Our ref: PSM1551-103L

**RE: GEOTECHNICAL ASSESSMENT - 103 BYNYA ROAD, PALM BEACH: RESPONSE TO RFI**

**Figure 1: Revised excavation and southwest retaining structure**

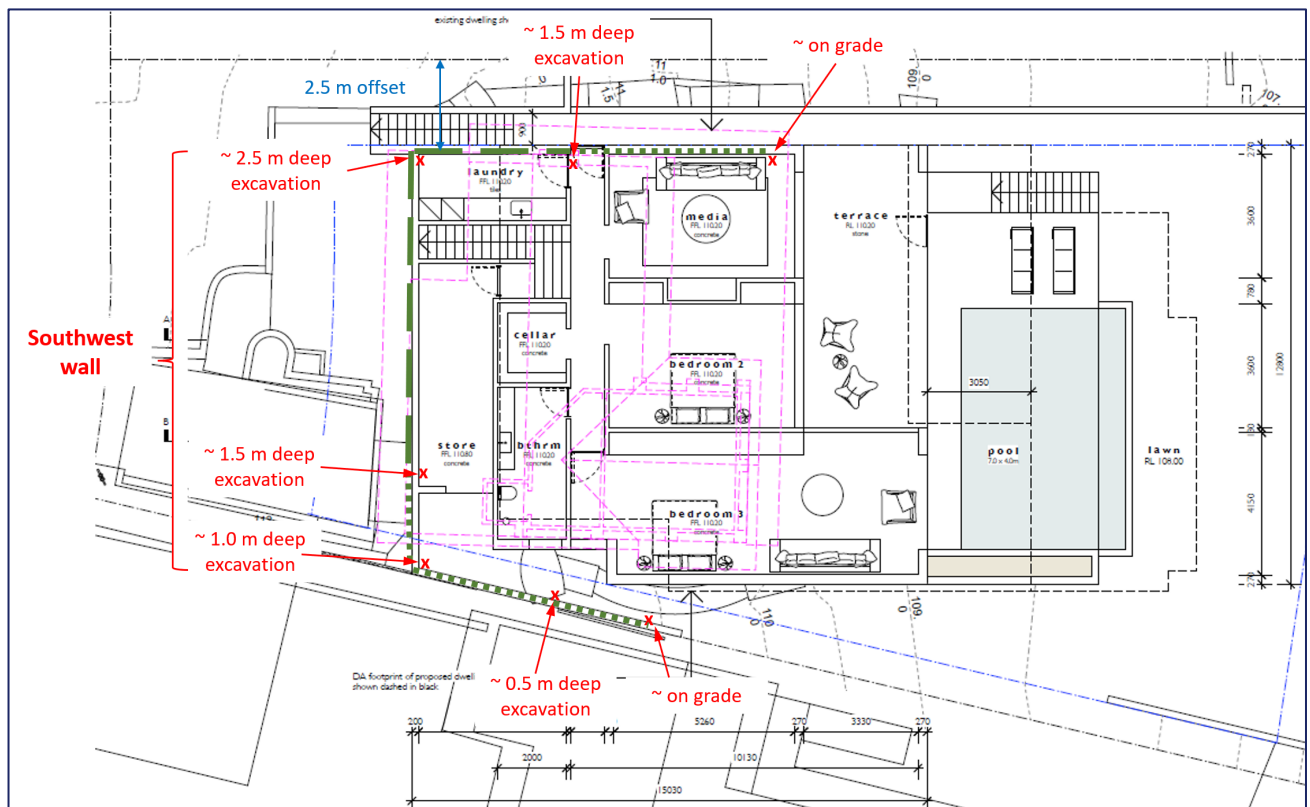
*It appears that the depth of the excavation for the proposed development is more than 1.5m.*

*The applicant needs to provide geotechnical risk management report as set out in Council's Geotechnical Risk Management Policy for Pittwater relating to the potential impact of excavation on Land Stability.*

- The revised dwelling design has been shifted toward the front boundary by 3050 mm with the lower floor level raised 0.5 m which has changed the depth of excavation.

- The lower level will be partly above grade and partly below grade with excavation along the southwest wall ranging between 1.0 m and 2.5 m deep.
- The portion of excavation along the southwest wall which is greater than 1.5 m deep is assessed to be at a distance of 2.5 m or more from the property boundary.

Given this assessment the revised development proposal does not include excavation depths of greater than 1.5 m at a distance of less than 1.5 m from the boundary of the property.

Overall, review of the changes in the revised plans do not alter findings and recommendations in report PSM1551-100L dated the 20<sup>th</sup> December 2022. Accordingly, the property at 103 Bynya Road Palm Beach is assessed as being suitable for the proposed revised development with regard to slope stability.
